Re: 49 CFR Part 573: Recall of Mercedes-Benz M-Class

Campaign No.2003040005
June 2003

SUBJECT: MODEL 163.154/157/172/174/175
REPLACEMENT OF CLAMP FOR LOWER POWER STEERING HOSE DUE TO
POSSIBLE FLUID LOSS AT RADIATOR

Figure 1

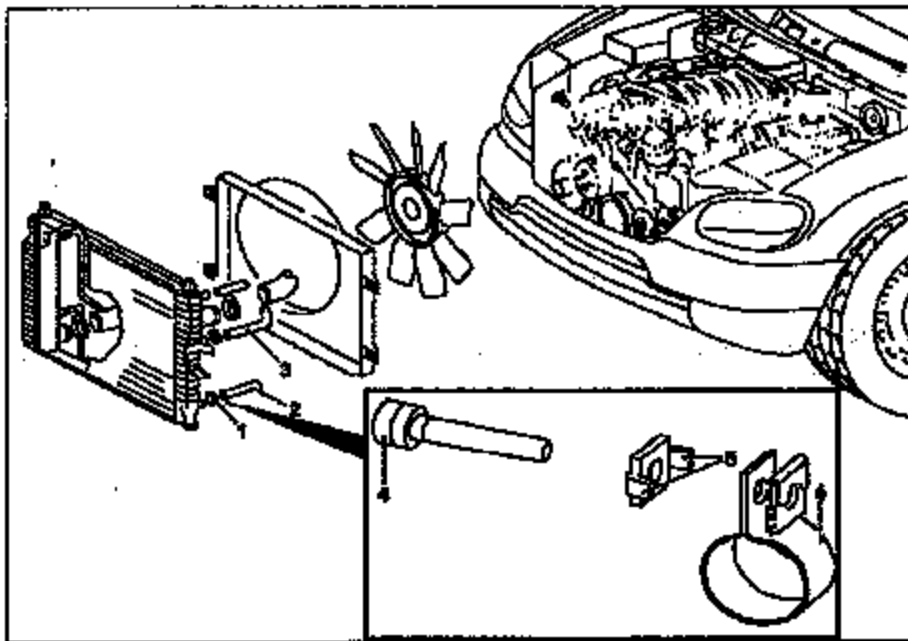
DCAG has determined that the lower power steering hose clamp (1, Figure 1) located on the lower power steering hose (2, Figure 1) at the lower left hand corner of the radiator must be replaced, with a new clamp (6, Insert, Figure 1). The hose clamp may not provide sufficient clamping force for this connection and may cause fluid loss.

1. Prior to performing this Recall Campaign, please check VMI to insure the vehicle is involved and to determine if the vehicle has been previously repaired.
2. Shut-off engine and remove ignition key from ignition lock.
3. Open engine hood.
4. Visually locate both upper (3, Figure 1) and lower (2, Figure 1) power steering hose and then using MBUSA Special Tool: 000 589 40 37 00, clamp off (near radiator) both upper and lower power steering hoses to prevent any fluid leaks.
5. Carefully loosen only, the existing hose clamp (1, Figure 1) and then slide hose clamp away from the radiator. Do not remove existing hose clamp at this point.

In order to prevent power steering fluid leak, do not disturb or remove lower power steering hose (2, Figure 1) in any way.

6. Carefully inspect the condition of the lower power steering hose (2, Figure 1) at the radiator.

Figure 2

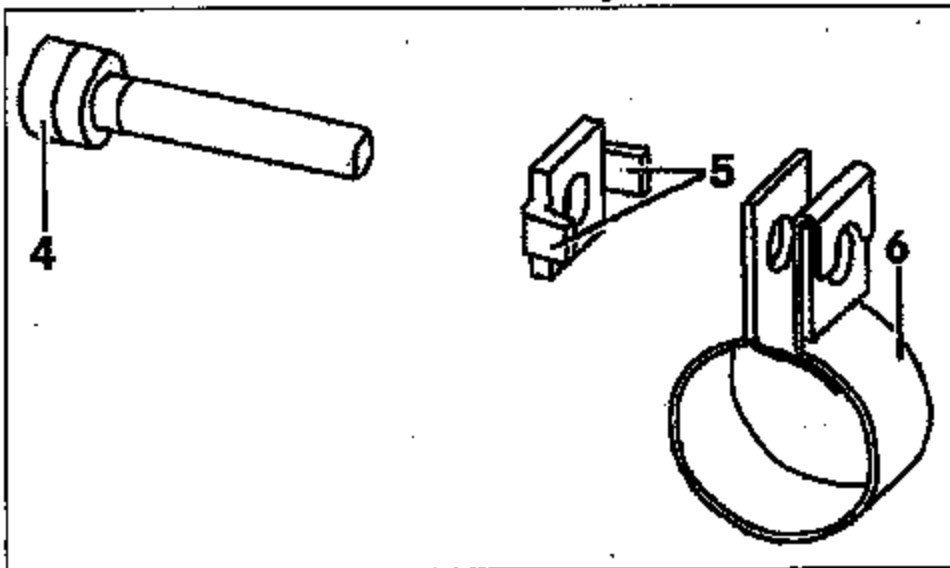
7. Open replacement hose clamp (6, Figure 2) just enough for clamp to fit over the outer circumference of the lower power steering hose (2, Figure 1).

i NOTE: The new replacement hose clamp (6, Figure 2) must have the number "Nr St 15" stamped into the outer circumference of the hose clamp surface. Any other type of hose clamps must not be used.

8. Slide the installed new hose clamp toward the radiator and locate in the proper position on the lower steering hose (1, Figure 1) as shown and tighten hose clamp screw (4, Figure 2).

Ⓢ Observe tightening torque of: Nm 2.0 + .5 / - 0.0 and proper orientation of the anti-rotation tabs (5, Figure 2).
